Chan	ge Bulletin	Tesco Corporation 5616 – 80th Avenue SE
No: CB053	Rev: 0	Date: November 30, 2013	Calgary, Alberta, Canada T2C 4N5 Tel: 1-877-TESCO-77 (North America)
HMI Ge	arbox –	MK1 Quill Assembly	Tel: 1 (713) 359-7195 (AMSS 24-hour support) Tel: 1 (713) 359-7295 (International) Email: bulletins@tescocorp.com www.tescocorp.com www.tescoparts.com
☑ Intern	al Use Or	nly External Use	☐ Mandatory

Figure 1: Original HMI gearbox quill connection

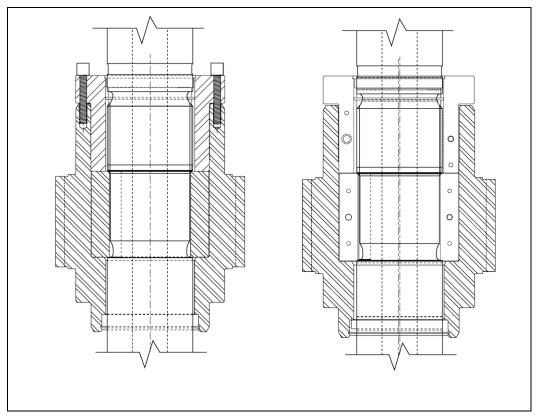
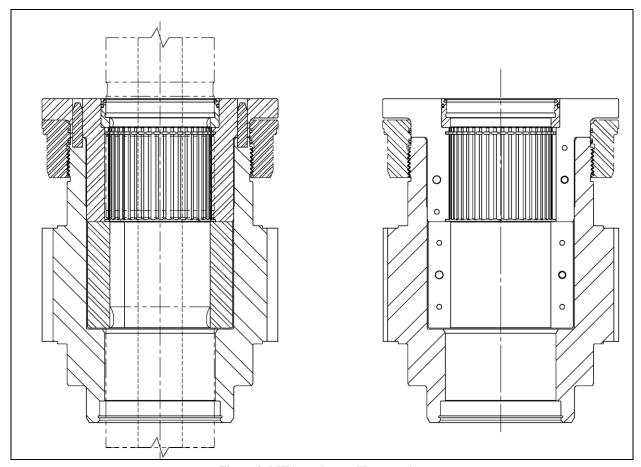
With the shift to horizontal drilling, the HMI top drive has been subject to increasingly demanding drilling programs. It was found that the connection from the drive gear to the quill's drive bushing could begin to slip and wear and eventually require repairs. To improve this connection, a prototype MK1 design was designed and several units were produced and tested. The performance of these prototypes in the field was established and determined to be an improvement over the initial design, proving to extend service life in the more extreme drilling programs. The prototype MK1 design was incorporated into several production units beginning in 2012. Based on feedback from the production and testing teams, some modifications were made to the prototype MK1 design to improve

The MK1 quill connection design increases the torque transmission capacity of the gearbox quill connection. Instead of directly fastening the drive bushing to the gear, a clamping ring is added between the drive gear and the drive bushing. The 12 threaded holes on the quill gear are replaced with a buttress thread to which the clamping ring is assembled. The connection between the new drive bushing and the clamp ring is now sixteen 5/8 in.-11UNC cap screws on a 10.50 in. base circle diameter (BCD). Increasing the number and size of the cap screws increases the clamping force between the drive bushing and the gear, greatly reducing the potential for slippage and the resulting wear. This also increases the torque transmission capacity.
